TECHNICAL NOTE

Project Title: Branch Hill, Hampstead

Report Reference: JNY9823-04-V2

HIGHWAYS CONSULTATION RESPONSE

PROPOSED BASEMENT PLAN

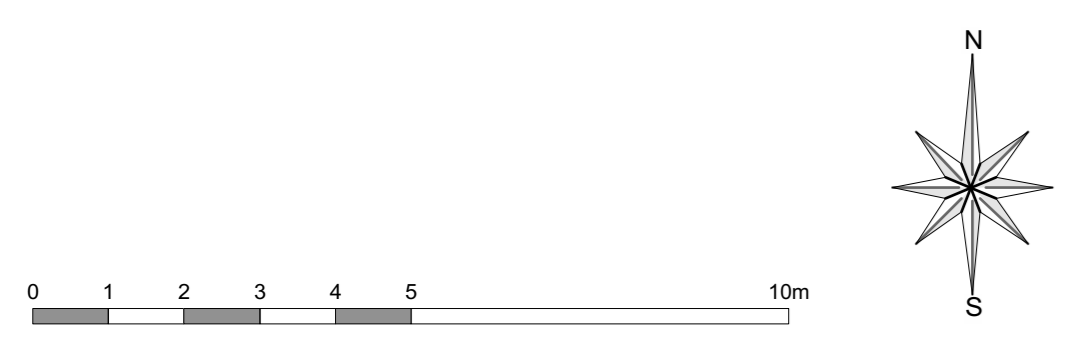
"I have some concerns about the provision of disabled parking for the new development. The proposals show 4 disabled spaces in the basement accessed via a vehicle lift.

The draft London Plan states that developments must ensure that there is one disabled parking space for 3% of dwellings, and that it is available from the outset. This would equate to 1 space in this case. The London Plan goes on to say that a Parking Design and Management Plan should demonstrate how an additional 7% of dwellings could be provided with one disabled persons parking space per dwelling in future. This equates to a possible further 3 spaces (rounded up from 2.4)."

- 1.8 Camden's consultation response states:
- “We also need more information on the cycle parking. The basement plan describes the spaces as bike lockers, however there is no further information on the type of cycle parking provided. It appears there is insufficient space to store two cycle per locker as they have proposed.”

- 1.6 Policy T6.1 is a *minimum* requirement. As a minimum for the proposed development of 34 dwellings, there is a requirement to provide one disabled car parking space with the ability to be able to provide a further three spaces (rounded up from 2.4 spaces) in the future, i.e. a total *minimum* of four car parking spaces.
- 1.7 Whilst we do not agree with Camden's full interpretation of the Intend to Publish London Plan disabled parking requirements, which are a *minimum* requirement, the basement layout has been amended to show the provision of one disabled car parking space from the outset, with the remaining three indicated as potential future provision should demand require (see **Appendix 1**).

- 1.13 The updated basement layout plan (see **Appendix 1**) incorporates the provision of 78 long-stay cycle parking spaces including four (i.e. 5%) 'non-standard' spaces in the form of cycle storage lockers, which is slightly in excess of and therefore in accordance with Camden Council's aspirations. Furthermore, two short-stay cycle parking spaces are to be provided in the form of Sheffield style stands located adjacent to the main entrance.
- 1.14 Details of the storage lockers are provided at **Appendix 2**, demonstrating that the proposed provision is suitable to accommodate the required number of cycle parking spaces.

- 1.16 It is considered that the proposed disabled car parking provision accords with the minimum requirements of the Intend to Publish London Plan (December 2019). Notwithstanding the basement layout plan has been amended to illustrate the provision of one disabled car parking space from the outset with three additional spaces marked for potential future provision should demand require, in accordance with Camden Council's preference.

- 1.17 The amended basement layout plan provides a small amount of additional cycle parking and incorporates the provision of 5% larger cycle parking spaces in accordance with the emerging Intend to Publish London Plan and the aspirations of the Camden Planning Guidance on Transport. Details of the proposed form of cycle parking has also been provided, demonstrating that the proposed provision is suitable to accommodate the required number of cycle parking spaces.
